CONTAINMENT SYSTEMSCONTAINMENT STRUCTURAL INTEGRITYLIMITING CONDITION FOR OPERATION

3.6.1.6 The structural integrity of the containment shall be maintained at a level consistent with the acceptance criteria in Specification 4.6.1.6.

FIGURE 4.6-1

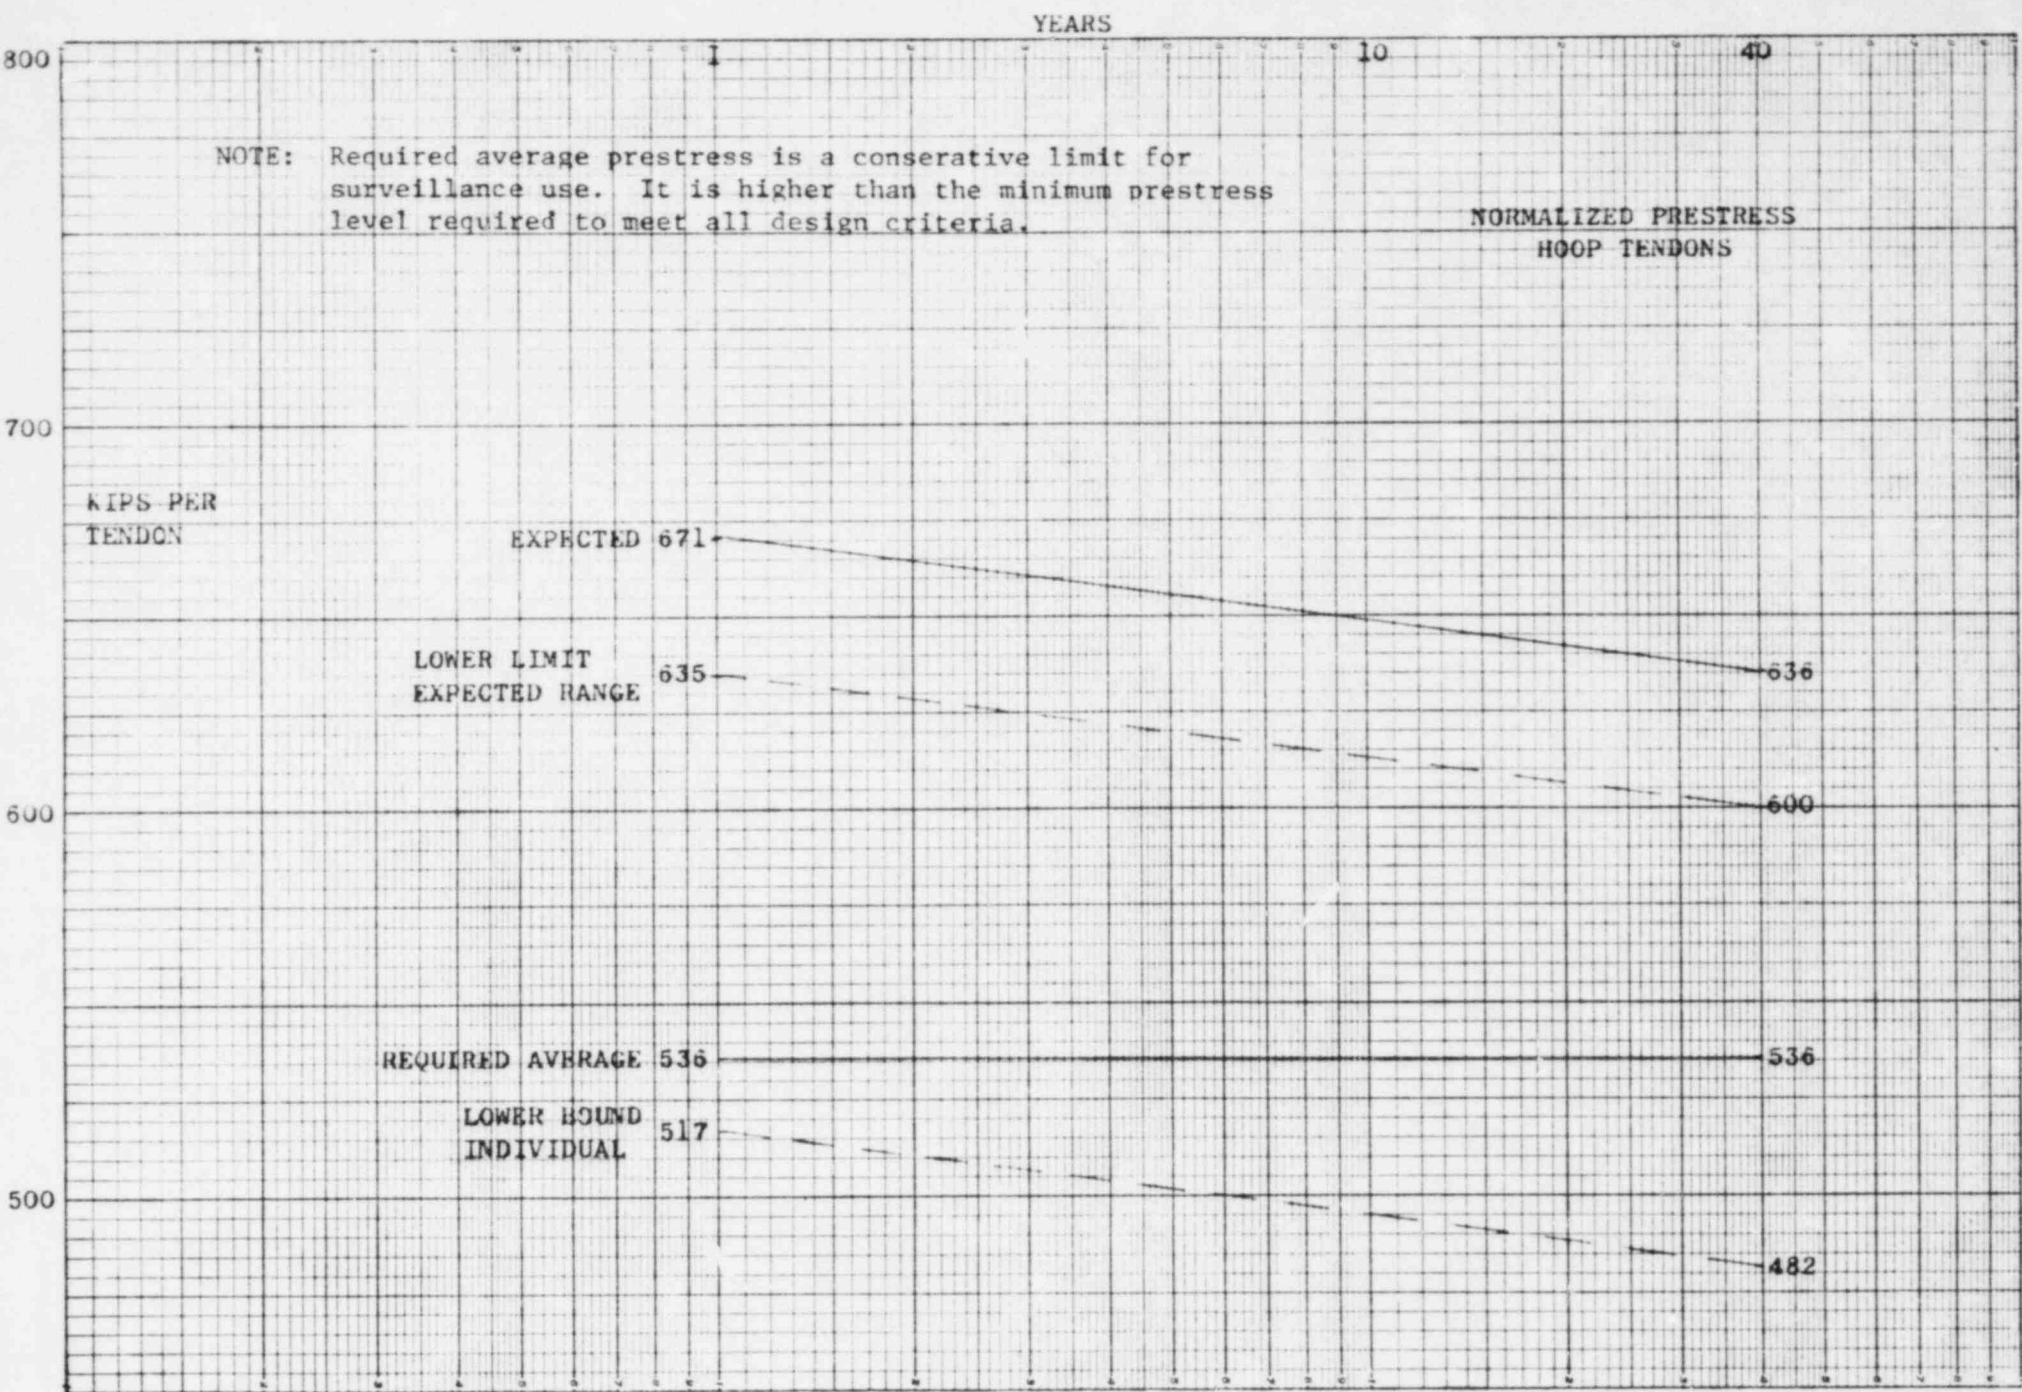
- a. Determining that for a representative sample of at least 21 tendons (6 dome, 5 vertical, and 10 hoop), each tendon has a normalized lift-off force equalling or exceeding its lower limit expected range for the time of the test (see Figures 4.6-1, -2, and -3). If the normalized lift-off force of any one tendon in a group lies between the lower limit expected range and the lower bound individual, an adjacent tendon on each side shall be checked for lift-off force. If both of these tendons are found acceptable, the surveillance program may proceed considering the single deficiency as unique and acceptable. If either of the adjacent tendons is found unacceptable, it shall be considered as evidence of possible abnormal degradation of the containment structure.

In addition, determining that the average of the normalized lift-off forces for each sample population (hoop, vertical, dome) is equal to or greater than the required average prestress level; 536 kips for hoop tendons, 622 kips for vertical tendons, and 555 kips for dome tendons (reference Figures 4.6-1, -2, and -3). If the average is below the required average prestress force, it shall be considered as evidence of possible abnormal degradation of the containment structure.
